UNITED STATES PATENT AND TRADEMARK OFFICE

10/791,772	03/04/2004	Takashi Naganawa	520.43593X00	4408
------------	------------	------------------	--------------	------

Office Action Summary	Application No. 10/791,772	Applicant(s) NAGANAWA ET AL.	
	Examiner Zachary M. Pape	Art Unit 2835

DETAILED ACTION

Fig 1

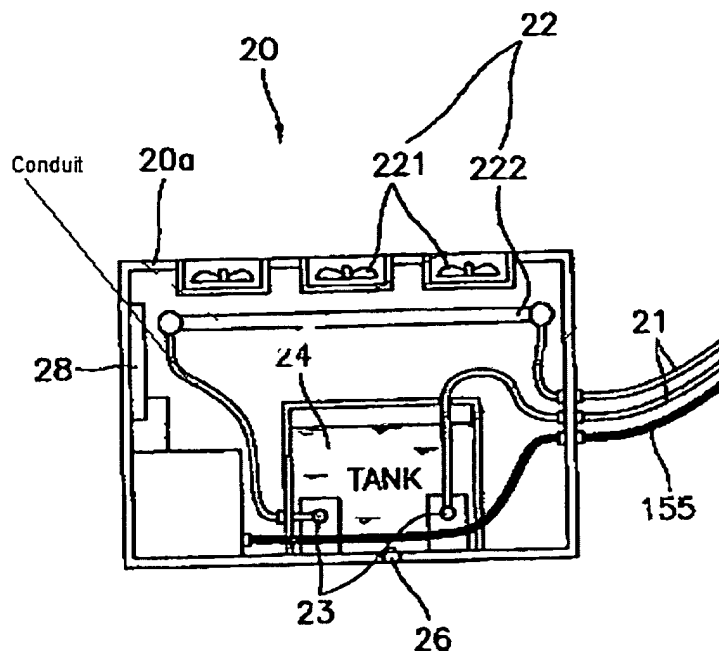
With respect to claim 1, Cheon teaches a liquid cooling system (20), comprising: a heat-receiving jacket (11) for absorbing heat of a heat-generation element through a liquid flowing with an inside thereof; a radiator (222) for radiation heat from a surface thereof; and a pump (23) for transporting said liquid absorbing the heat therein to said radiator, wherein said pump is connected to said radiator, directly (As illustrated in Fig 1).

With respect to claim 2, Cheon teaches a liquid cooling system (20), comprising: a heat-receiving jacket (11) for absorbing heat generated from a semi-conductor through a liquid, which is enclosed within an inside thereof; a radiator (222) being connected with said heat-receiving jacket (11) through a flexible conduit (21) therebetween; a tank (24) being connected to said radiator through a conduit (See Present office action Fig 1 below); and a pump (23) for circulating said liquid, further comprising: a plural number of fins being attached onto a metal conduit of said radiator passing the liquid passes therethrough (See Paragraph 43, Line 3 – also see Cheon Fig 5), wherein said pump is connected to said tank (As illustrated in Cheon Fig 1), which is connected to said metal conduit, directly (Via the conduit as illustrated in the present office action Fig 1 below).

Fig 2

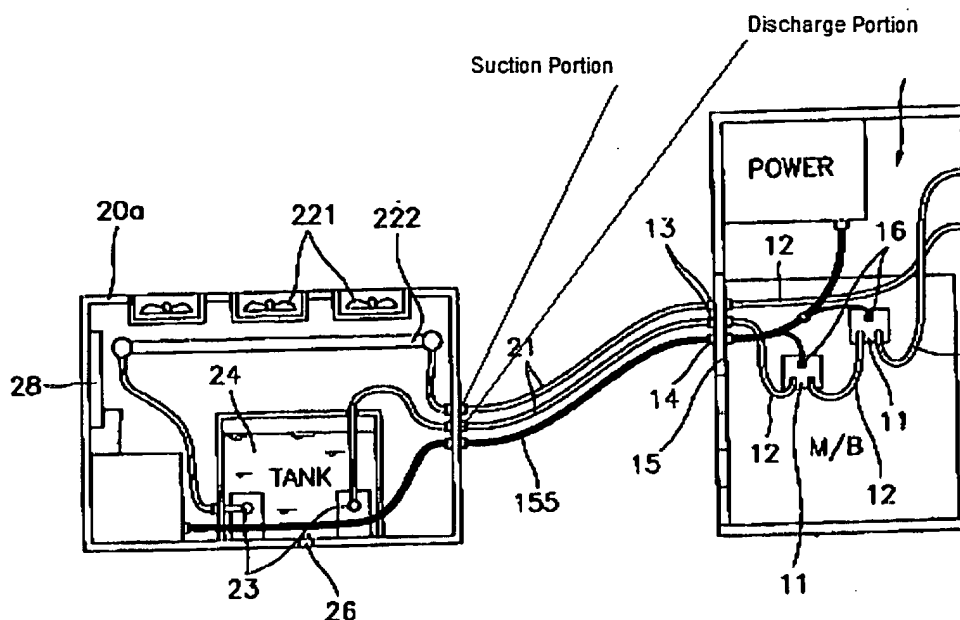
With respect to claim 8, as best can be understood by the examiner, Cheon teaches a liquid cooling system (20), comprising: a heat-receiving jacket (11) for absorbing heat generated from a semiconductor element through a liquid enclosed in an inside thereof; a radiator (222) being connected to said heat-receiving jacket through a conduit (See present office action Fig 1 above); and a pump (23) for circulating said liquid, wherein: a member building up said cooling system has a suction port (See present office action Fig 2 below) and a discharge port (See present office action Fig 2 below), and is connected by inserting those ports into port insertion openings, which are provide in said conduits (The suction port and discharge port of the "built up" cooling system are connected to the conduits via openings in the conduits such that the fluid can flow from the cooling system to the conduit and vice versa).
